<b>Notice of Allowability</b>	Application No.	Applicant(s)
	10/604,640	GANESAN, KRISHNAMURTHY
	Examiner John P. Fitzgerald	Art Unit 2856

## DETAILED ACTION

FIG.2

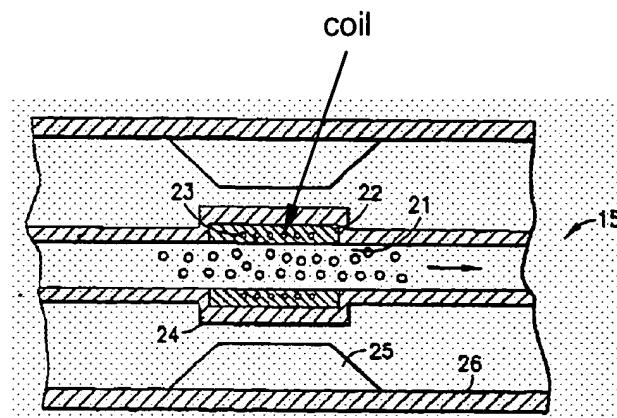
All the Prior Art teach the measurement of the resistivity or electrical properties of formation fluid by employing coils and having the formation fluid pass axially through the coils, however, the coils "excite" (i.e. magnet resonance imaging) aspects of the formation fluid, and in turn, pick-up/measure the signals induced in the formation fluid either with the same coil or additional coils spaced from one another. An example of this, and which is considered the closest Prior Art example by the Examiner, is US 6,825,657 to Kleinberg et al., which discloses a method/apparatus (see Figs. 2 and 4 below) for determining the resistivity of formation fluids employing a coil, however, there is not reasonable modification or teaching, alone or with another Prior Art reference, to employ the "quality factor" of the coil itself to determine the

resistivity of the formation fluid, as in the instant application, employing a "reference quality factor" and a "measured quality factor" (i.e. with the fluid located within the coil).
